**PRELIMINARY OVERALL
DEVELOPMENT PLAN**

MONTE VIEJO SUBDIVISION

Re: Monte Viejo (Amendment)

MDP #723-A

PEDESTRIAN CIRCULATION SYSTEM

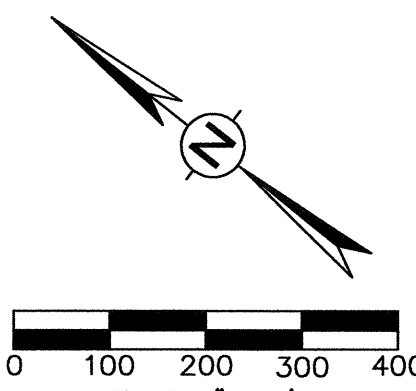
Comments: Provide sidewalks in R.O.W. per
U.D.C. ART. 5, Div. 2: 35-506 g.

Comments: Provide sidewalks in R.O.W. per
UDC. ART. 5, DIV. 2: 35-506.9.

STREET SECTION "A-A"
NTS

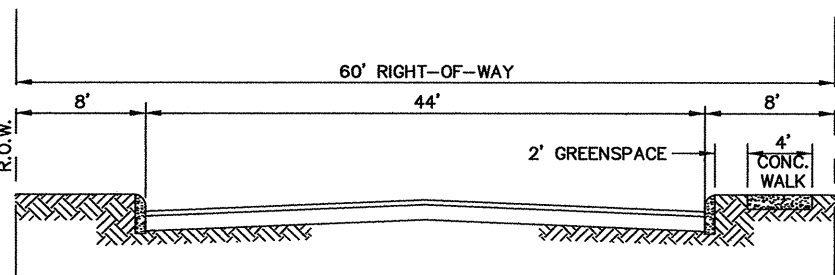
2. Dedication of 2.99 acre park with approximately 50% boundary by streets. Park is to be connected to Greenway.
3. Dedication of 4.05 acres on the southern boundary of the development, across the street from the 2.99 acre park. Access from Type "B" street with a minimum width of 40 feet is required.
